**ADDENDUM NUMBER**

**06**

**April 1, 2024**

**PROJECT: MORGAN COUNTY EVENTS CENTER  
ARCHITECT: GOODWYN MILLS CAWOOD  
OWNER: MORGAN COUNTY COMMISSION**

C-201

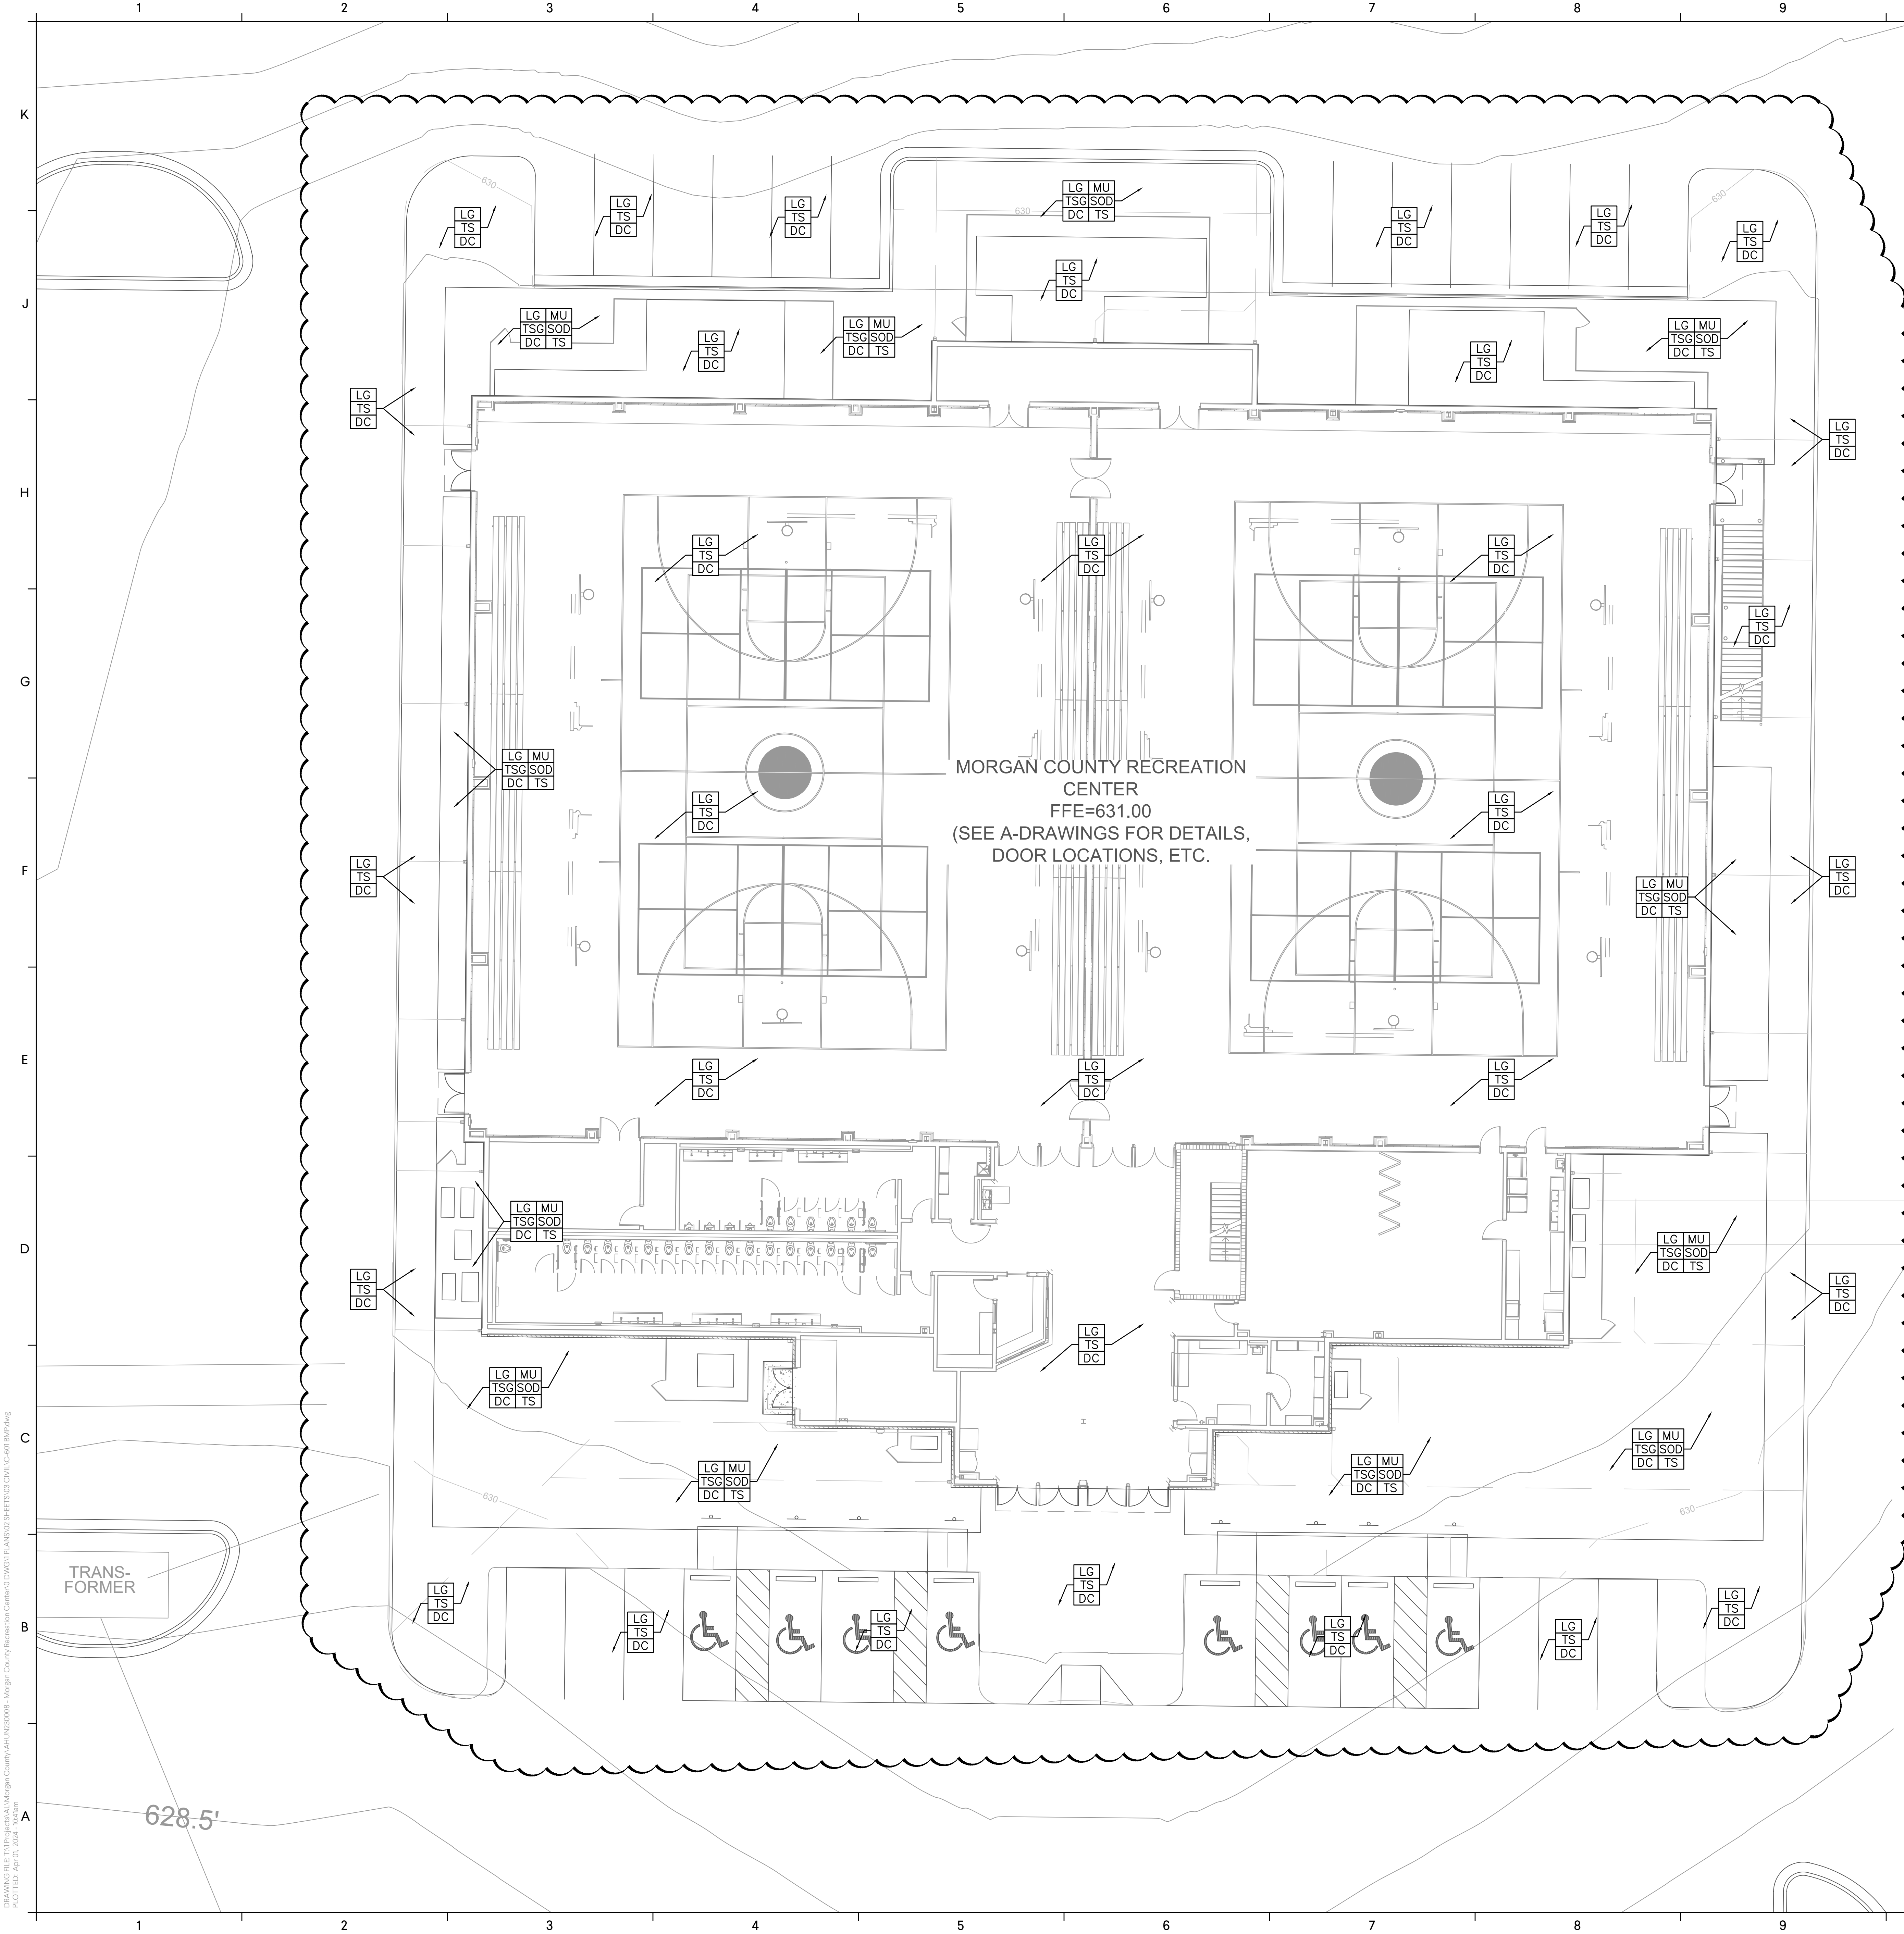
- A. Prior clarifications regarding downspouts to be disregarded. **Per this Addendum 6: Tie in downspouts per attached Civil drawings.**
- B. Disregard previous note on C-601 for "permanent seeding." **Per this Addendum 6: C-601, note #6 seeding will be "Zoysia sod" or as noted on the sheet.**
